# **Attachment C**

**Submissions**

**Subject:** Submission - D/2015/966/G - 155 Mitchell Road ERSKINEVILLE NSW 2043 - Attention Jessica Symons

Streets), to increase street wall height to Metters and MacDonald Streets from 5 storeys to 7 storeys, increase the overall height in storeys of the southern building from 7 storeys to 8 storeys and increase the height of roof forms. The concept modification is being assessed concurrently with detailed design proposal D/2023/842.

##### **Street wall height increase from 5 to 7 storeys**

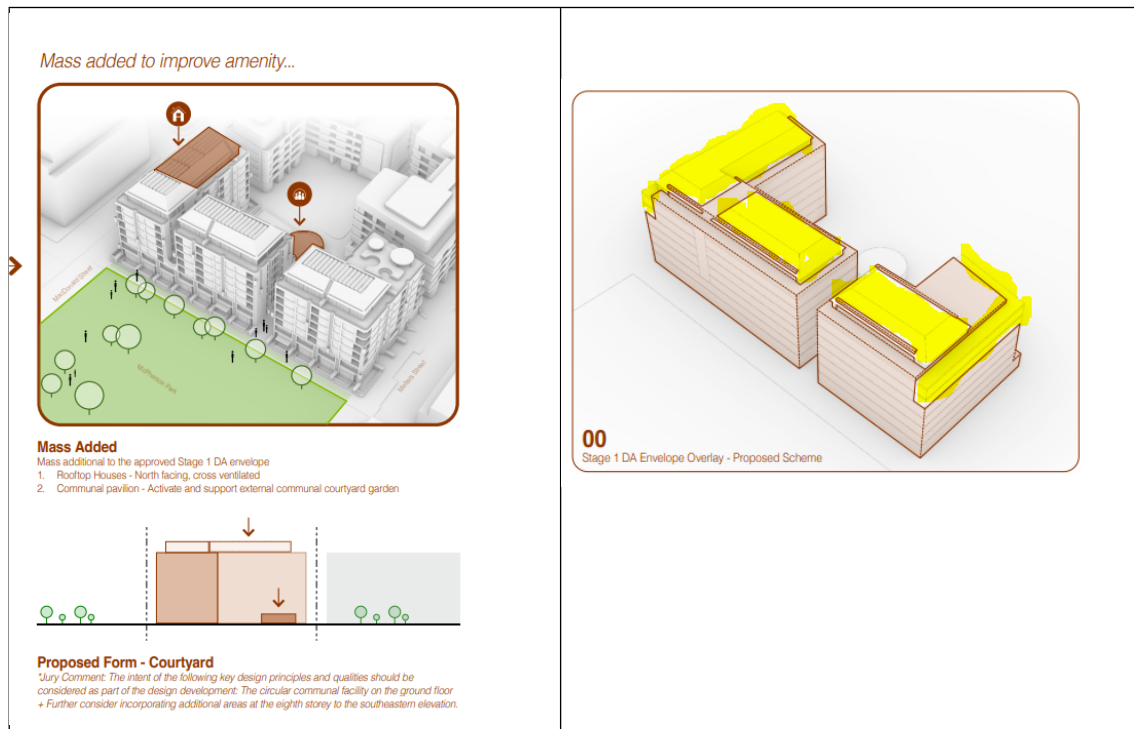
- The additional street wall height is an arbitrary application, not considering the scale and grain of the neighbourhood. The predominant scale of Macdonald Street is five storeys, with additional height set back from the street wall.
- The application reports have no consideration of the street wall height and rhythm of Macdonald Street. The context of the neighbourhood is completely ignored.
- There are overshadowing impacts increased in the morning to the west and afternoon to the east, including additional overshadowing of the proposed McPherson Park.
- The density of the neighbourhood means enjoyment of public space, including streets and parks, is critical. Additional impacts to amenity because of increased bulk must be considered in this context.
- The Statement of Environmental Effects simply lists impacts, and does not justify them appropriately.

- The concept drawings do not show an analysis of the broader neighbourhood, only the area around the proposed park. This seeks to minimise the effect of the increase in height by not showing the scale of surrounding built form.

- The design report for the increase in height arbitrarily summarises that the additional mass 'adds amenity'. This is an incorrect statement and ignores the planned and existing amenity of residents at 74 Macdonald Street – notably access to sky, light and an understanding of building separation as per the approved concept plan. The statement that the additional mass 'adds amenity' is wrong. The City of Sydney should not be swayed by simplistic urban arguments that do not pay attention to existing approvals or to the

**That the Concept Development Application D/2015/966/G be refused and that the Detailed Development Application D/2023/842 be significantly amended to conform to the approved height and envelopes of the already approved concept plans for the subject site.**

### Concept:

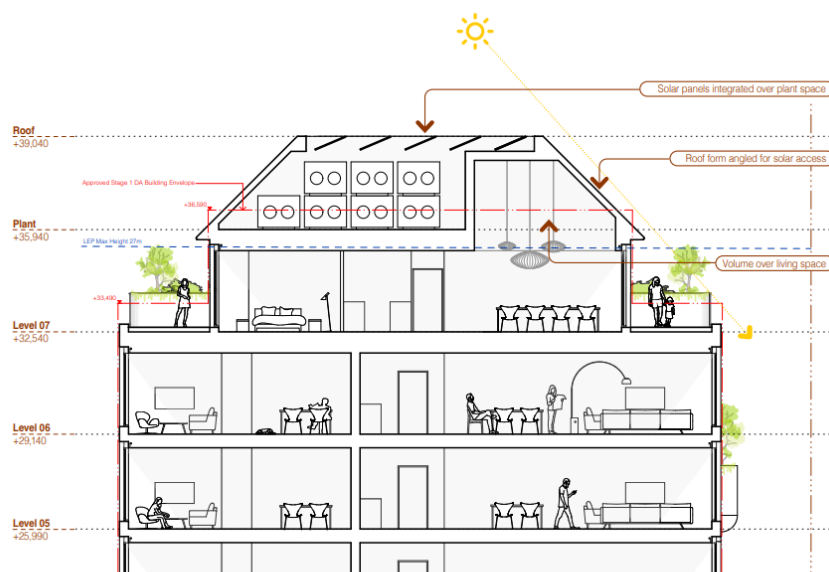
- Question viability of suspended trees, particularly those over communal lanes, with regard to wind, viability of growth, ongoing increase in weight as tree matures, resultant maintenance and appearance. A simpler design approach would be more suitable to the functional aesthetic of Erskineville.
- The scale of roof levels and the obtrusive mansard is inconsistent with the character of Erko. The raked roof is dominating and detracts from the simple character of residential apartment buildings within the locality. A simpler design approach would be more suitable to the functional aesthetic of Erskineville.

- The proposal seeks to preference amenity for its own residents to the detriment of the broader neighbourhood. A more communal consideration of amenity, and applying a less selfish design approach would help to provide a basis for reduced bulk consistent with the approved concept plans.

- In trying to maximise FSR on the site, the height provisions have been substantially breached. FSR is an upper limit, and should not be the driver of design outcomes. The character of the neighbourhood has not informed the design response.

- The application proposes two additional storeys adjacent to Casa II in lieu of the intended consistent maximum height of 7 storeys. The plant level is particularly large and bulky and its architectural resolution with use of mansard roof increases the bulk of the building.
- The application is over the LEP height and Stage 1 concept DA approval height.
- Open balconies to two levels at the corner of the building does nothing to diminish the appearance of the bulk.

**Transition of Building Heights' in Section 5.5.2 of the DCP:**

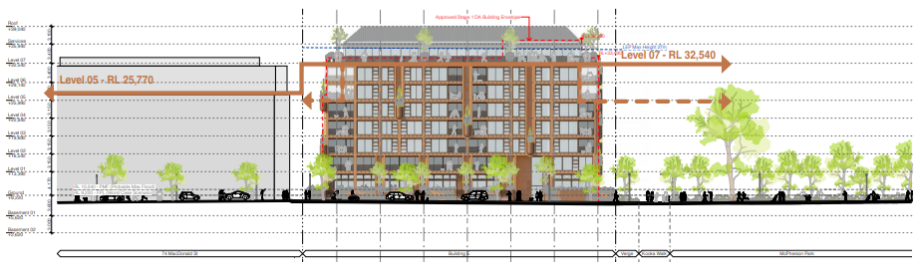
It is proposed to vary the Stage 1 DA envelope by prioritising the park frontage building height rather than the secondary streets. The resulting form provides a clear marker to the public park. This approach aligns with the intent of the urban design principle of:

Along MacDonald Street it can be seen in the adjacent diagram that the Stage 1 DA envelope generally aligned with the adjacent building street wall. It should be noted that the approved Stage 1 DA envelope does not nominate any RL for these side street walls relying only on a number of storeys. As such, it could be viewed that some flexibility exists to vary these street wall heights.

##### **Street wall height increase from 5 to 7 storeys**

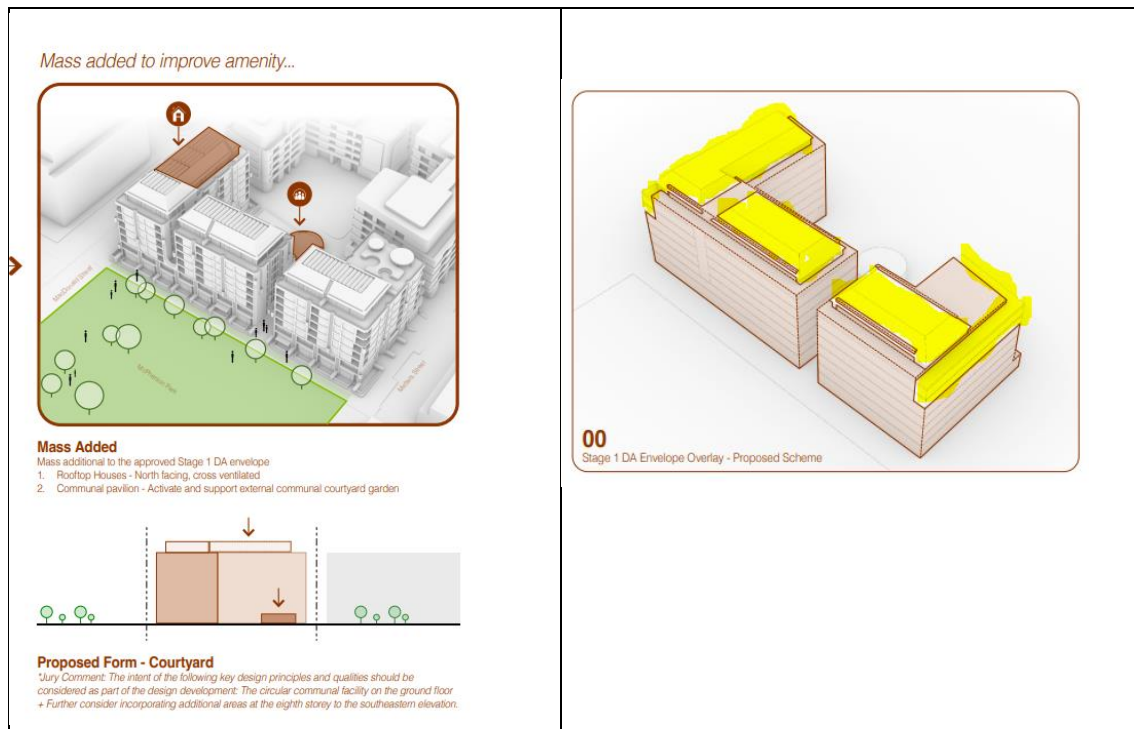
- The additional street wall height is an arbitrary application, not considering the scale and grain of the neighbourhood. The predominant scale of Macdonald Street is five storeys, with additional height set back from the street wall.
- The application reports have no consideration of the street wall height and rhythm of Macdonald Street. The context of the neighbourhood is completely ignored.
- There are overshadowing impacts increased in the morning to the west and afternoon to the east, including additional overshadowing of the proposed McPherson Park.
- The density of the neighbourhood means enjoyment of public space, including streets and parks, is critical. Additional impacts to amenity because of increased bulk must be considered in this context.
- The Statement of Environmental Effects simply lists impacts, and does not justify them appropriately.

- The concept drawings do not show an analysis of the broader neighbourhood, only the area around the proposed park. This seeks to minimise the effect of the increase in height by not showing the scale of surrounding built form.

- The design report for the increase in height arbitrarily summarises that the additional mass 'adds amenity'. This is an incorrect statement and ignores the planned and existing amenity of residents at 74 Macdonald Street – notably access to sky, light and an understanding of building separation as per the approved concept plan. The statement that the additional mass 'adds amenity' is wrong. The City of Sydney should not be swayed by simplistic urban arguments that do not pay attention to existing approvals or to the

**That the Concept Development Application D/2015/966/G be refused and that the Detailed Development Application D/2023/842 be significantly amended to conform to the approved height and envelopes of the already approved concept plans for the subject site.**

### Concept:

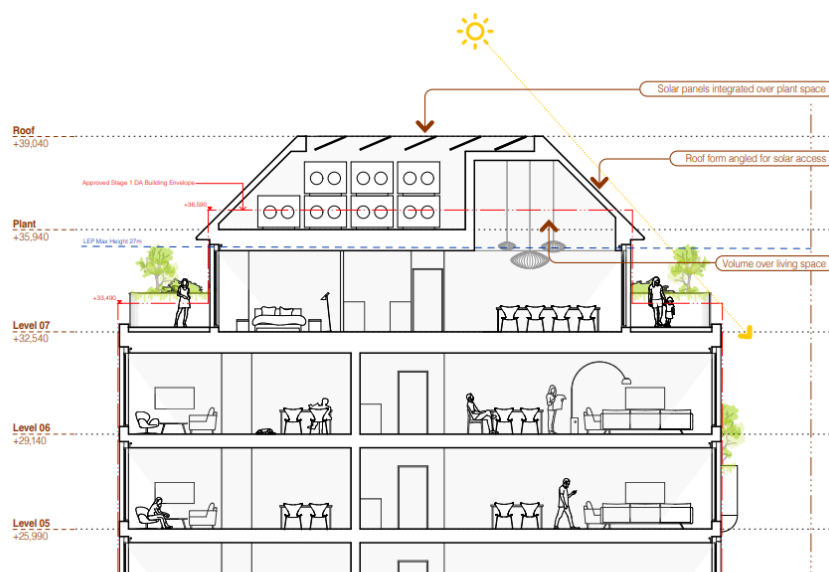
- Question viability of suspended trees, particularly those over communal lanes, with regard to wind, viability of growth, ongoing increase in weight as tree matures, resultant maintenance and appearance. A simpler design approach would be more suitable to the functional aesthetic of Erskineville.
- The scale of roof levels and the obtrusive mansard is inconsistent with the character of Erko. The raked roof is dominating and detracts from the simple character of residential apartment buildings within the locality. A simpler design approach would be more suitable to the functional aesthetic of Erskineville.

- The proposal seeks to preference amenity for its own residents to the detriment of the broader neighbourhood. A more communal consideration of amenity, and applying a less selfish design approach would help to provide a basis for reduced bulk consistent with the approved concept plans.

- In trying to maximise FSR on the site, the height provisions have been substantially breached. FSR is an upper limit, and should not be the driver of design outcomes. The character of the neighbourhood has not informed the design response.

- The application proposes two additional storeys adjacent to Casa II in lieu of the intended consistent maximum height of 7 storeys. The plant level is particularly large and bulky and its architectural resolution with use of mansard roof increases the bulk of the building.
- The application is over the LEP height and Stage 1 concept DA approval height.
- Open balconies to two levels at the corner of the building does nothing to diminish the appearance of the bulk.

**Transition of Building Heights' in Section 5.5.2 of the DCP:**

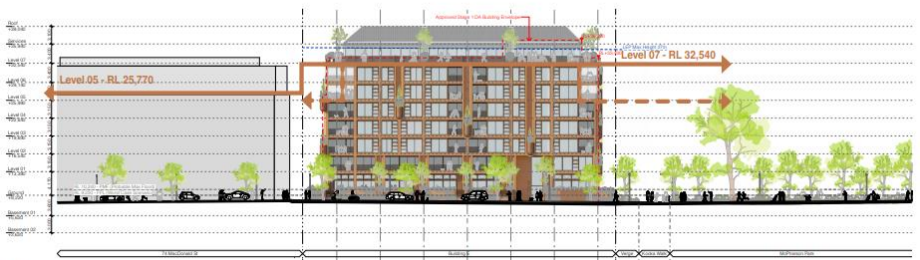
It is proposed to vary the Stage 1 DA envelope by prioritising the park frontage building height rather than the secondary streets. The resulting form provides a clear marker to the public park. This approach aligns with the intent of the urban design principle of:

Along MacDonald Street it can be seen in the adjacent diagram that the Stage 1 DA envelope generally aligned with the adjacent building street wall. It should be noted that the approved Stage 1 DA envelope does not nominate any RL for these side street walls relying only on a number of storeys. As such, it could be viewed that some flexibility exists to vary these street wall heights.

**Street wall height increase from 5 to 7 storeys**

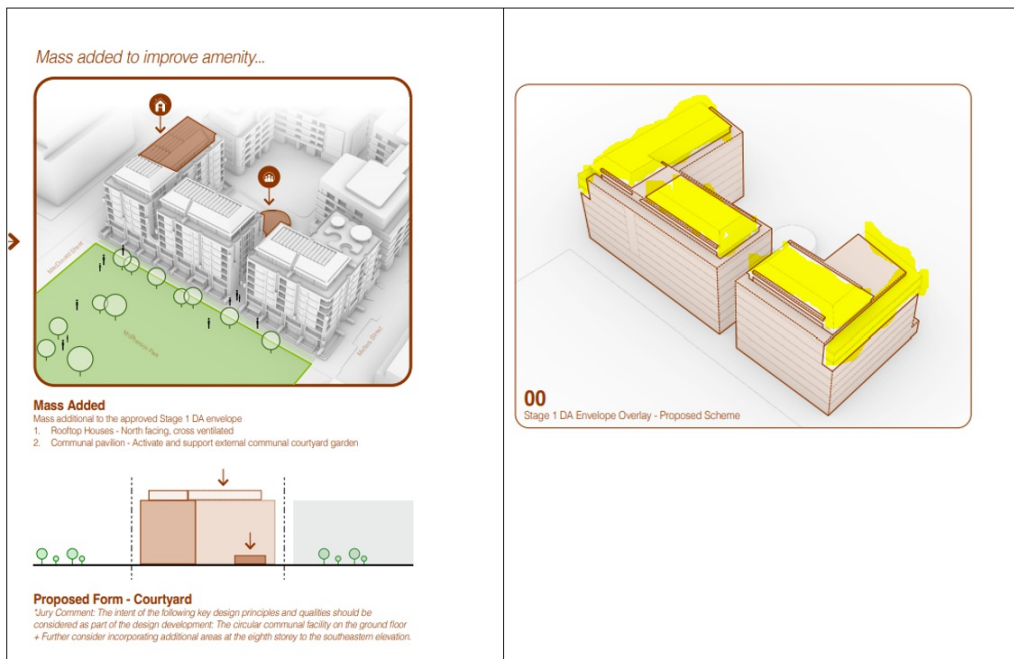
- The concept drawings do not show an analysis of the broader neighbourhood, only the area around the proposed park. This seeks to minimise the effect of the increase in height by not showing the scale of surrounding built form.

- The design report for the increase in height arbitrarily surmises that the additional mass 'adds amenity'. This is an incorrect statement and ignores the planned and existing amenity of residents at 74 Macdonald Street – notably access to sky, light and an understanding of building separation as per the approved concept plan. The statement that the additional mass 'adds amenity' is wrong. The City of Sydney should not be swayed by simplistic urban arguments that do not pay attention to existing approvals or to the existing and intended pattern of street wall heights and building bulk along Macdonald Street.

That the Concept Development Application D/2015/966/G be refused and that the Detailed Development Application D/2023/842 be significantly amended to conform to the approved height and envelopes of the already approved concept plans for the subject site.

### Concept:

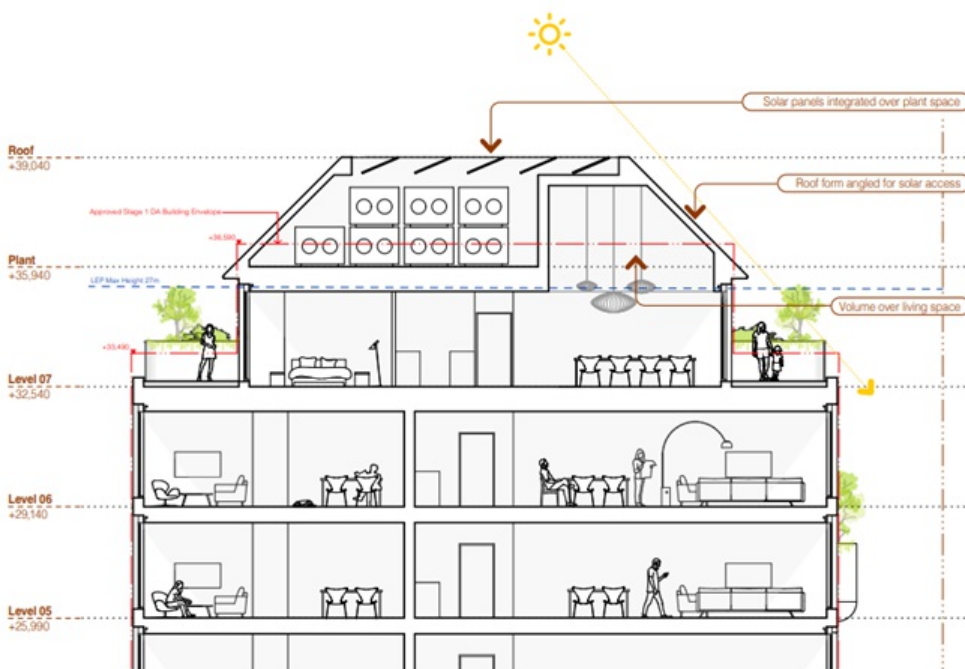
- Question viability of suspended trees, particularly those over communal lanes, with regard to wind, viability of growth, ongoing increase in weight as tree matures, resultant maintenance and appearance. A simpler design approach would be more suitable to the functional aesthetic of Erskineville.
- The scale of roof levels and the obtrusive mansard is inconsistent with the character of Erko. The raked roof is dominating and detracts from the simple character of residential apartment buildings within the locality. A simpler design approach would be more suitable to the functional aesthetic of Erskineville.

- The proposal seeks to preference amenity for its own residents to the detriment of the broader neighbourhood. A more communal consideration of amenity, and applying a less selfish design approach would help to provide a basis for reduced bulk consistent with the approved concept plans.

- In trying to maximise FSR on the site, the height provisions have been substantially breached. FSR is an upper limit, and should not be the driver of design outcomes. The character of the neighbourhood has not informed the design response.

- The application proposes two additional storeys adjacent to Casa II in lieu of the intended consistent maximum height of 7 storeys. The plant level is particularly large and bulky and its architectural resolution with use of mansard roof increases the bulk of the building.
- The application is over the LEP height and Stage 1 concept DA approval height.
- Open balconies to two levels at the corner of the building does nothing to diminish the appearance of the bulk.

**Street Wall - MacDonald Street**

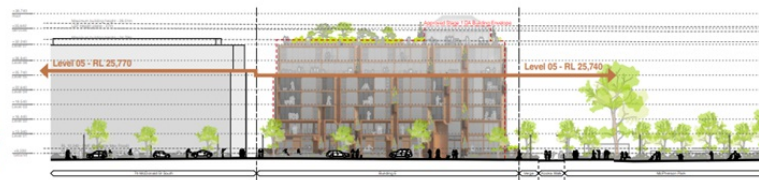
It is proposed to vary the Stage 1 DA envelope by prioritising the park frontage building height rather than the secondary streets. The resulting form provides a clear marker to the public park. This approach aligns with the intent of the urban design principle of:

*Figure 1. Overlooking concern from increased street wall condition to 7 Metters Street property. Please note the plan for 7MS has been updated to reflect the as built condition rather than initial DA scheme. Please note this highlights living space on north facing terrace.*

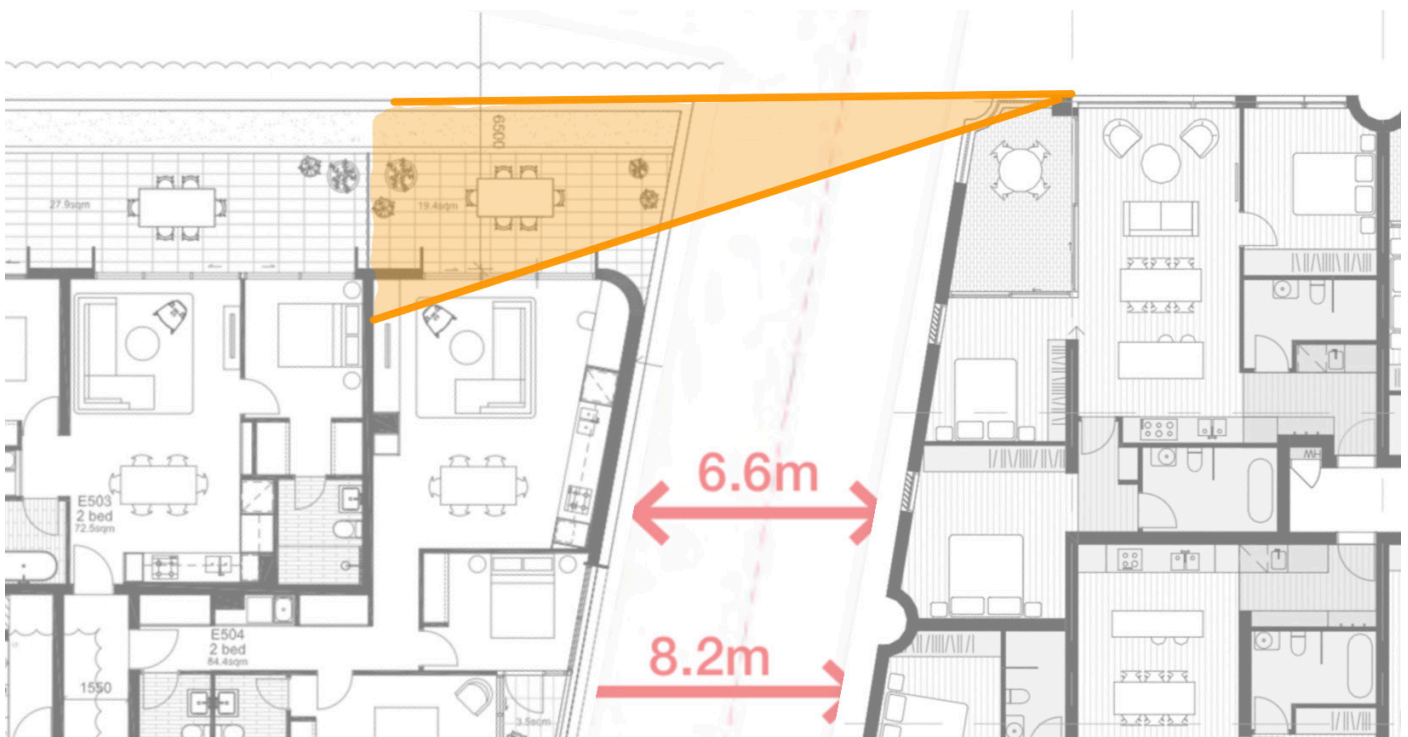
A greater street height has been added to 155MR when compared to the stage 01 scheme. These additions protrude beyond the stage 01 envelope and existing setback on the 7MS site, resulting in direct overlooking onto the balcony and into the living space of 7MS levels 5 and 6. The 155MR Stage 01 DA massing limited this issue to the terraces of level 5 7MS and level 5 115MR only.

Figure 2. Consented scheme - The 7 Metters Street has the level 5 terrace to match the stage 01 proposed for site E.

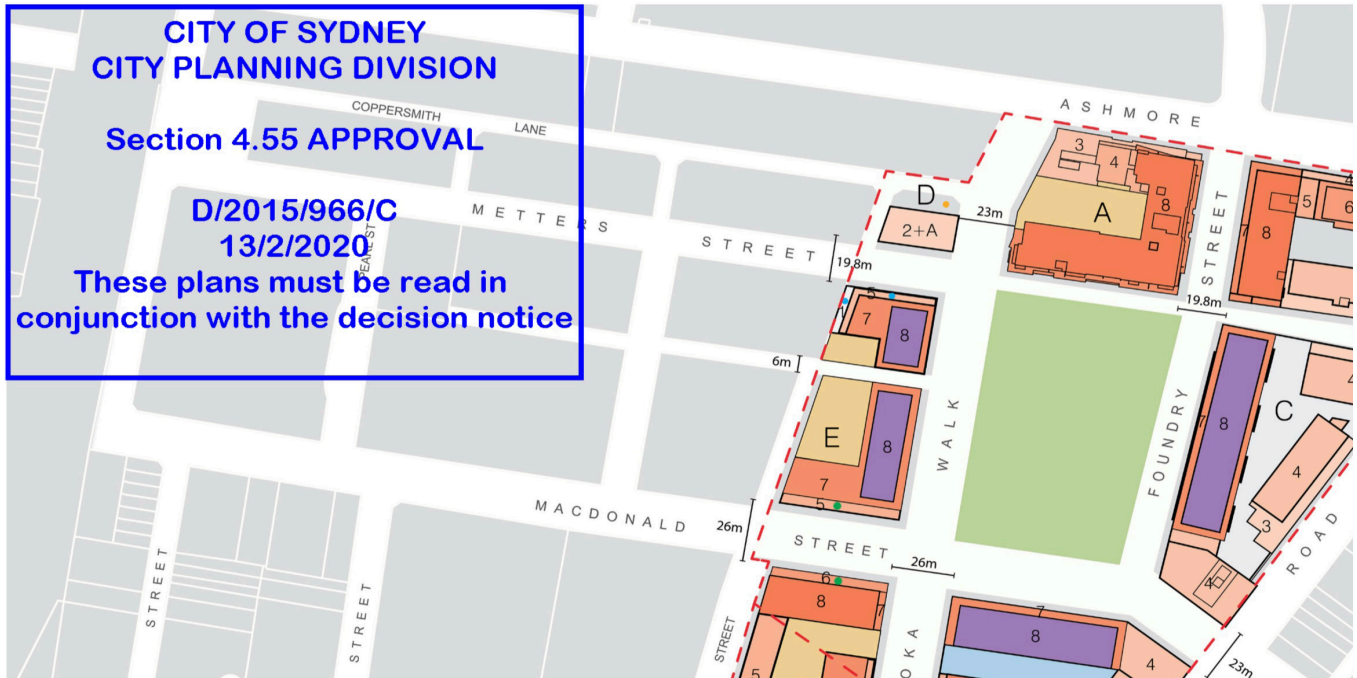
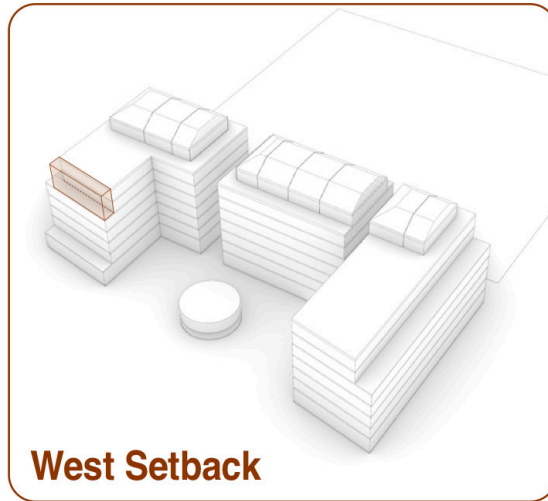
The figures below show the original stage 01 envelope and the new proposal. The applicant is seeking to substantially increase 155MR towards 7MS and the street, when the primary objective cited is to McPherson Park.

Figure 3. Amended scheme/application - The change to 7 story wall creates the overlooking.

Figure 4. Diagram highlighting massing changes - Street Wall condition

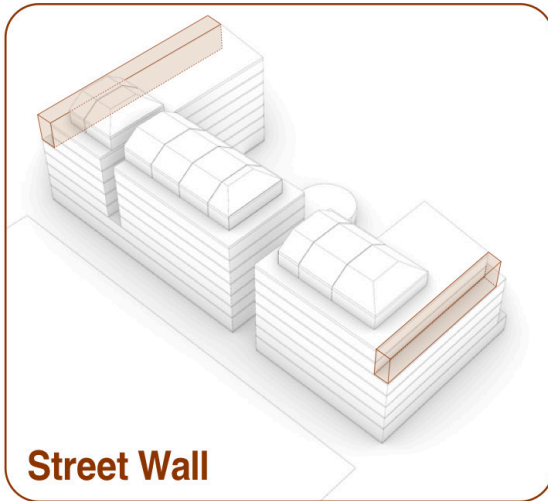
The diagrams below highlight the street wall increase and proposed open corner condition. These diagrams further reinforce the overlooking concern to the 7MS site caused by the forward position of the upper mass. Additionally, the open corners at 155MR Level 5 & 6 in the increased mass (adjacent neighbouring sites) are unscreened, causing the overlooking concern.

Refer to figure 8 for potential amendment to building incorporating setback and screening to 7MS
